402<sup>ND</sup> BATTALION IRAQI ARMY  
HEADQUARTERS BARRACKS  
AL HILLAH, IRAQ

**SIGIR PA-06-077**  
**JANUARY 29, 2007**

SUBJECT: Report on Project Assessment of the 402nd Battalion Iraqi Army Headquarters  
Barracks, Al Hillah, Iraq (Report Number SIGIR-PA-06-077)

**Site Photo 1. Barracks entrance door cross section**

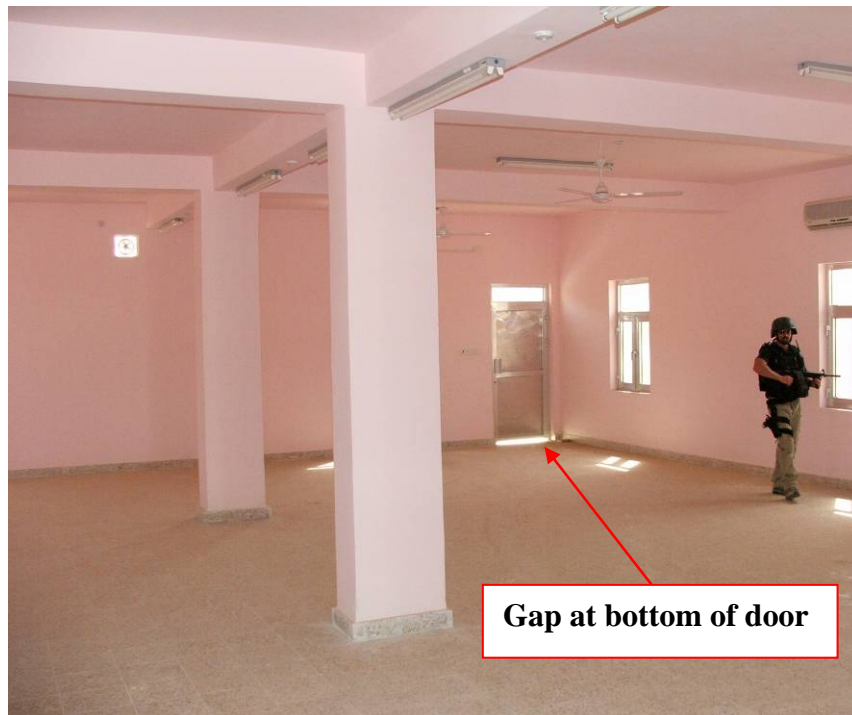
Although the interior appeared satisfactory, the two entry/exit aluminum doors in the barracks sleeping quarters did not appear to be "good quality," especially for the high traffic expected with a 75-man barracks. Site Photos 1 and 2 provide closer views of one of the aluminum doors and associated hardware. In addition, the doors did not have sweeps. Noticeable gaps were present between the thresholds and bottom of the doors as seen in the door shown in Site Photo 3.

**Site Photo 5. Vertical crack in front side of classroom building exterior**

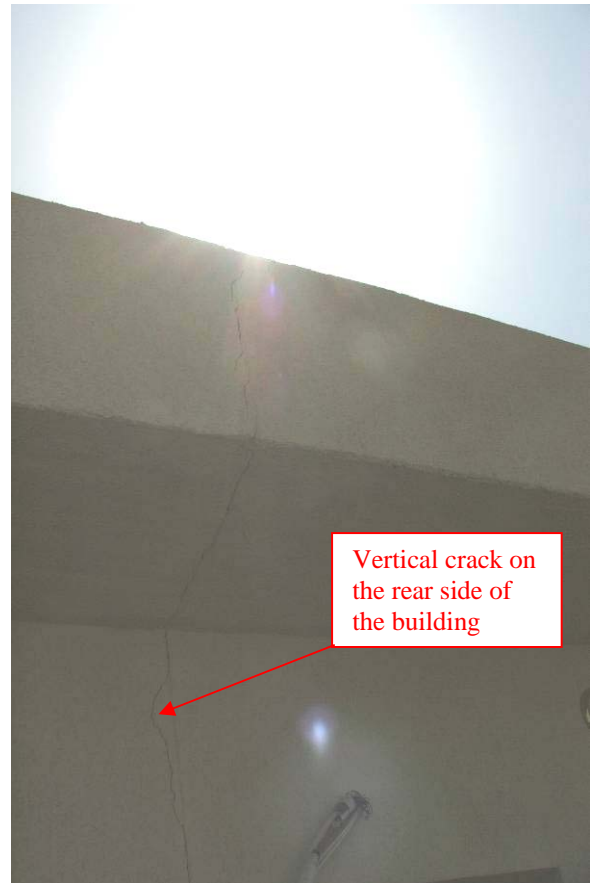
The design included two, two-ton HVAC units in each classroom augmented with a ceiling fan, and two wall exhaust fans, which we verified as installed. Overall, the building appeared satisfactory, except we did observe a noticeable crack in the exterior near the center of the building. The crack ran on both sides of the building, beginning at the sidewalk and continuing vertically in the wall and along the soffit and parapet as shown in Site Photos 5 and 6. The structural design for the building shows in the center of the building, a 480 mm masonry wall consisting of two, side by side masonry wall sections, each 240 mm thick. The design also shows the dual masonry walls supporting two adjoining bond beams, each 250mm thick. The design does not show any tying mechanism between the dual masonry walls or connecting reinforcing steel or dowels in the two concrete beams. Based on this design and the presence of the vertical crack along the building centerline, it appears there should be an expansion joint in the center of the building to allow for the differential movement of each side of the building.

**Figure 1. Design detail for covered parking (sunshade)**

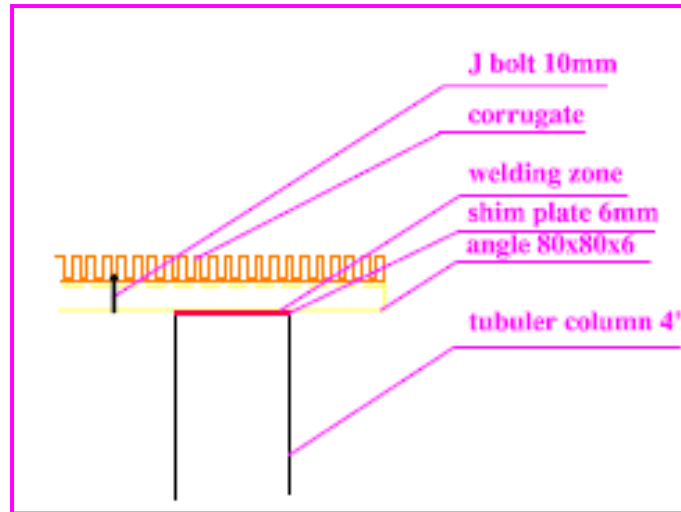
The design detail for the structural frame supporting the corrugated roof sheeting (Figure 1) showed an 80 x 80 x 6 angle supporting the roof sheeting. No units were provided for

the angle, although it is assumed the dimensions are in millimeters. Figure 1 also shows the angle welded to a shim plate at the top of the column. There were no details provided on the type or size of weld or the type and thickness of the corrugated roof sheeting. The design also did not show any lateral cross bracing perpendicular to the angle support shown in Figure 1.

**Site Photo 13. Typical column support for covered parking (sunshade)**

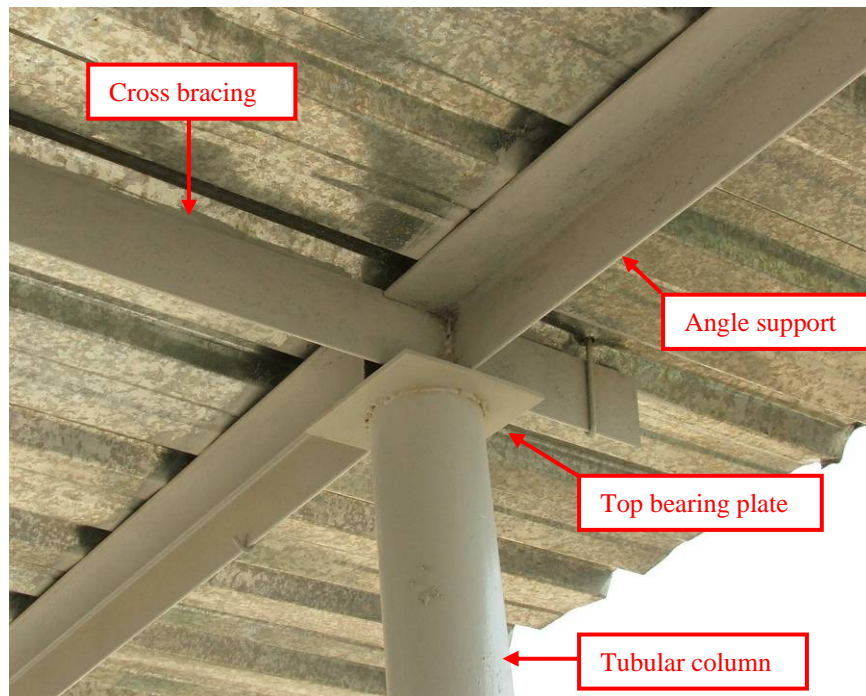
Site Photo 13 shows the actual welded angle connections at the bearing plate (i.e., shim plate) at the top of each tubular column. Also shown is the lateral cross bracing. The roof sheeting material appeared to be a thin gage sheet metal, connected to the frame with J-bolts as depicted in Figure 1.
